Amendments to the Drawings:

Title: INTEGRATION OF GAIN EQUALIZATION FILTER IN A GAIN MEDIUM

Docket No.: 15436.247.14.1

Fig. 3

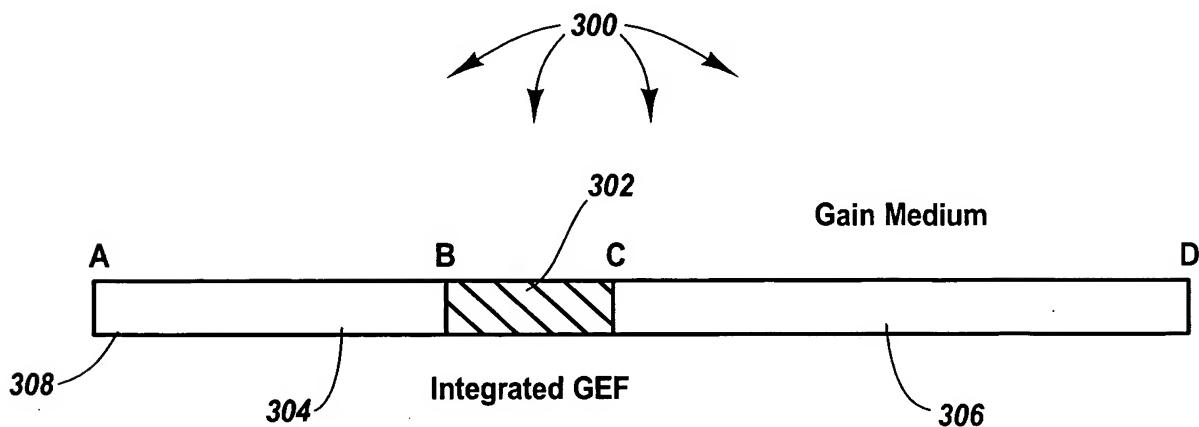
The attached sheet of drawings includes changes to Figure 3. This sheet, which includes Figures 3 and 4, replaces the original sheet including Figures 3 and 4. In Figure 3, references "A", "B", "C", and "D" described in detail in the specification but previously omitted from Figure 3 have been added.
